TECH TIP

Group:	11-ENGINE
Bulletin No:	TT-16-013
Issue Date:	10-19-2016
Reference:	HMM-161017-J1

CAM HOUSING BOLT TORQUE UPDATE

SUBJECT VEHICLES: 08MY-17MY Conventional Trucks

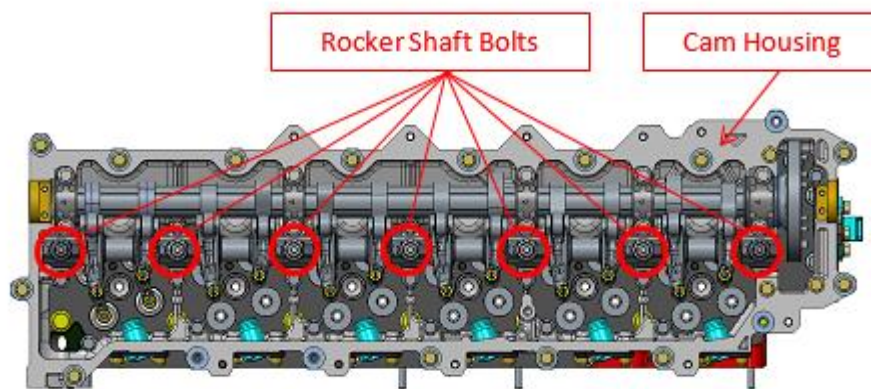
The procedure for installing the rocker shaft bolts into the cam housing has been updated. It is recommended to lightly lubricate the threads and flange of the bolts with clean engine oil before installing them. The torque specification has also been reduced as a result of adding lubricant to the bolts.

Apply Oil Here

Specified Torque: 33 lb-ft (45 Nm) (formerly 43.5 lb-ft (59Nm))
